# Tree report P 080.100 v3a

**09 April 2025**

**Conway Park  
Consolidated tree report**

Figure 3, tree protection fencing from ACD

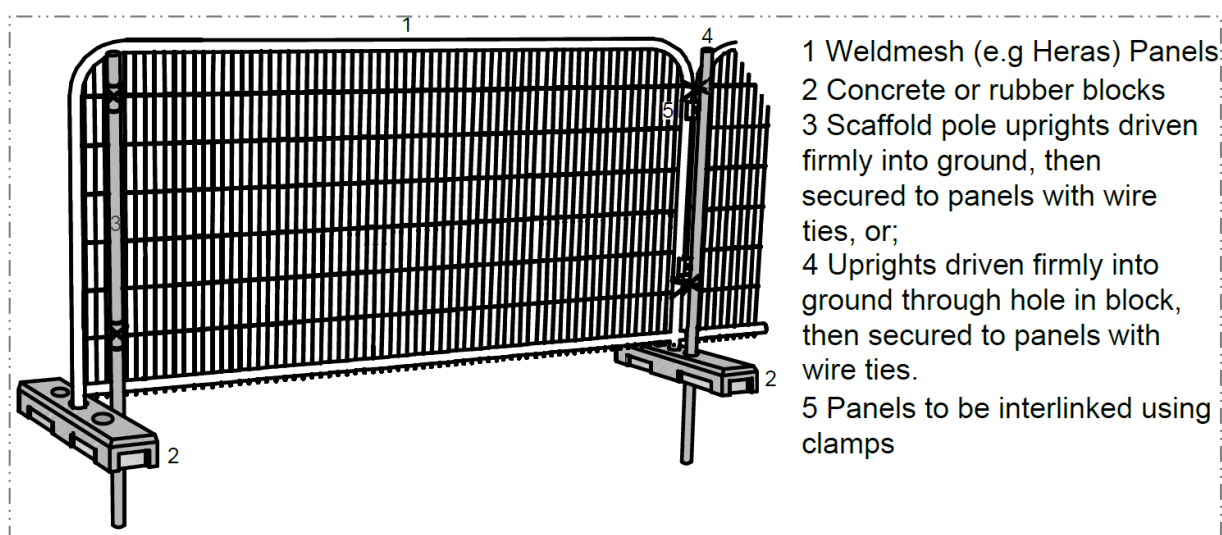
43 The specification for the temporary protective barrier fencing to create the CEZ was shown on the TPPR&T, reproduced in figure 3 below:

44 Therefore, the TPPR&T was incomplete as it did not reflect the working space required to construct the access and the tunnel.

Figure 4, an annotated extract from the RTPS from FDA

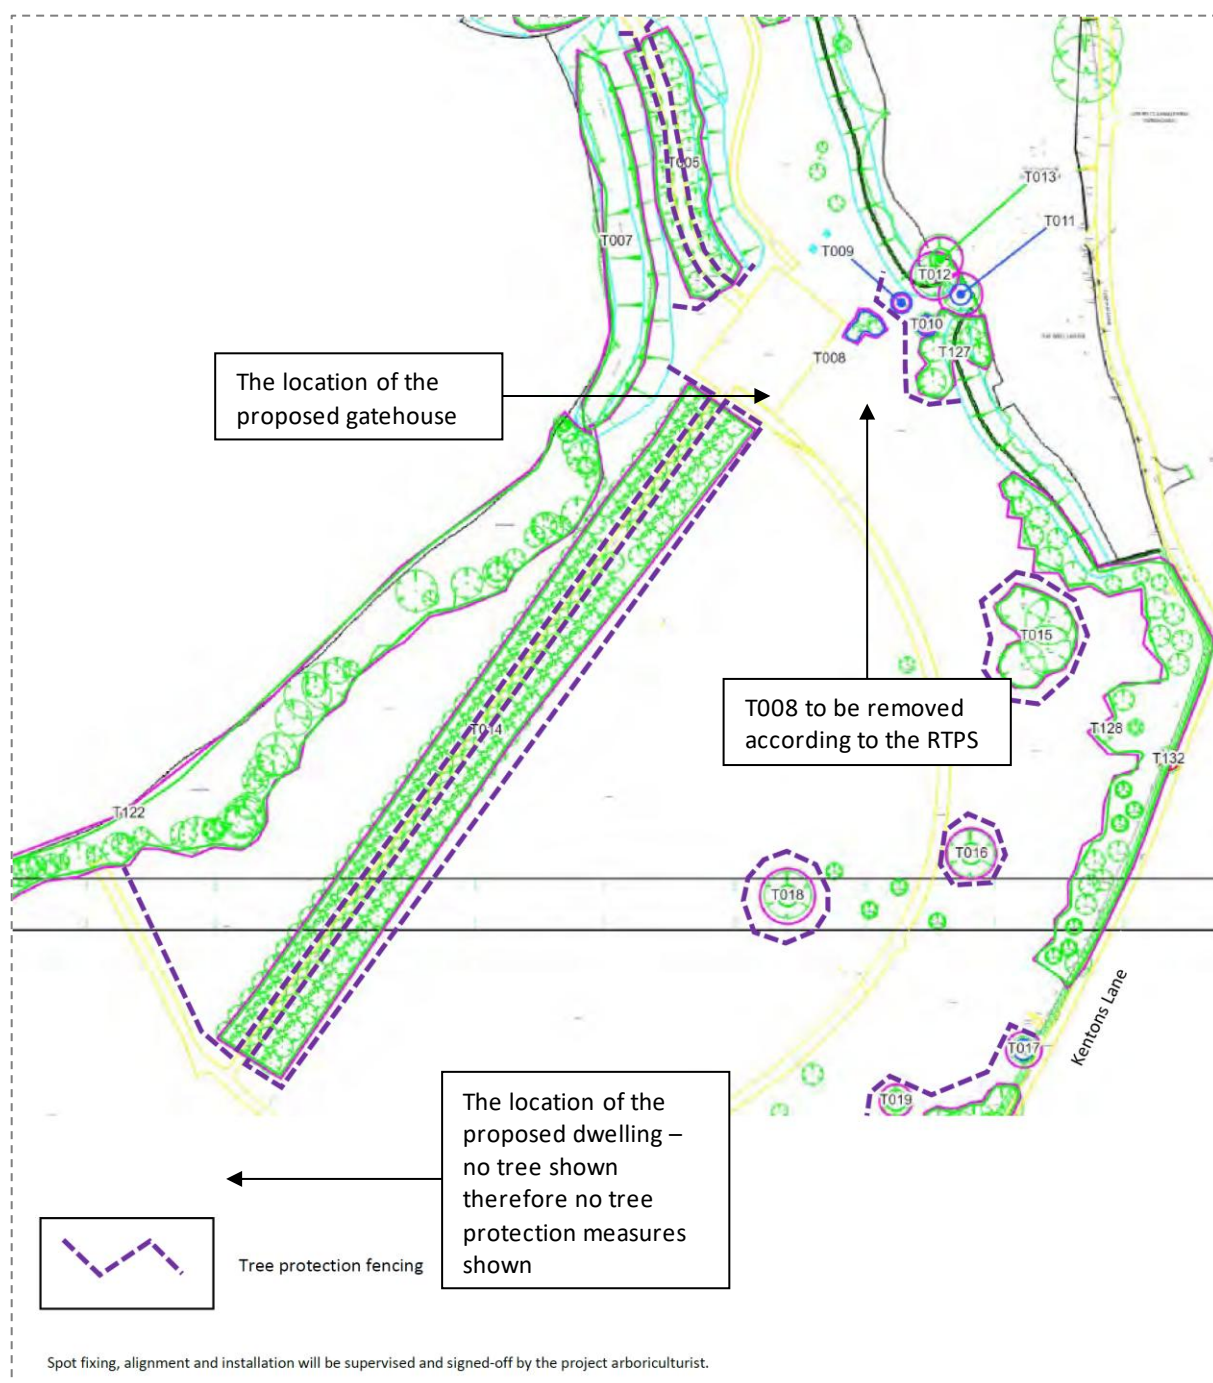
- 46 The RTPS shows the tree allée, individual trees, and tree groups some distance from the footprint of the proposed dwelling, as well as T008 identified for removal from adjacent to the proposed gatehouse, and includes the alignment of protective barrier fencing around each retained arboricultural asset to exclude site traffic from the soil at the trees' bases, see figure 4.

- 47 Notwithstanding the discrepancies between the landscape as shown on the RTPS and the evolving landscape, the tree protection recommendations with the RTPS as they pertain to this application would seem to be sound.

Figure 6, the TPR&T from ACD

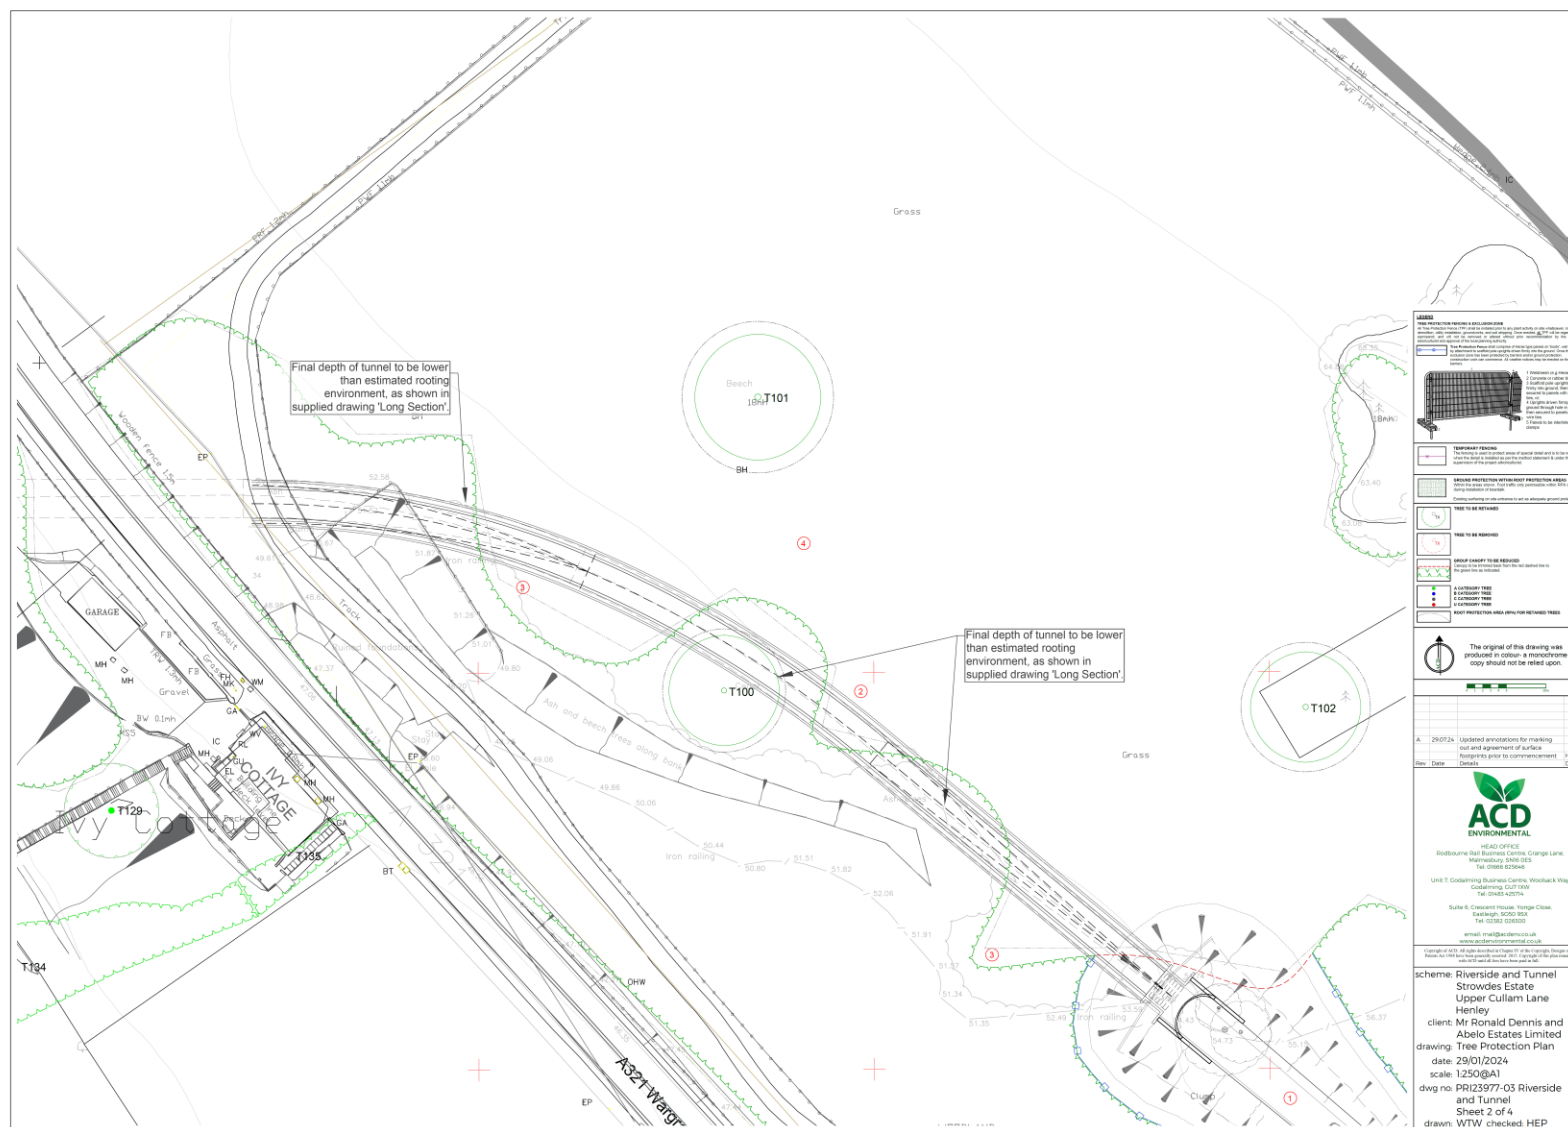
- 37 The TPPR&T did not attempt to identify the trees that would require to be removed for the construction of the tunnel, nor were individual any **Root Protection Areas** (RPA) plotted.

42 ACD proposed an alignment for the protective barrier fencing without identifying which trees would need to be removed to facilitate the construction of the access road and tunnel, and so the identification of the necessary tree losses was deferred until the final alignment had been agreed. Their proposed alignment related to the completed built form and made no allowance for the working space required to construct the road or to excavate the tunnel.
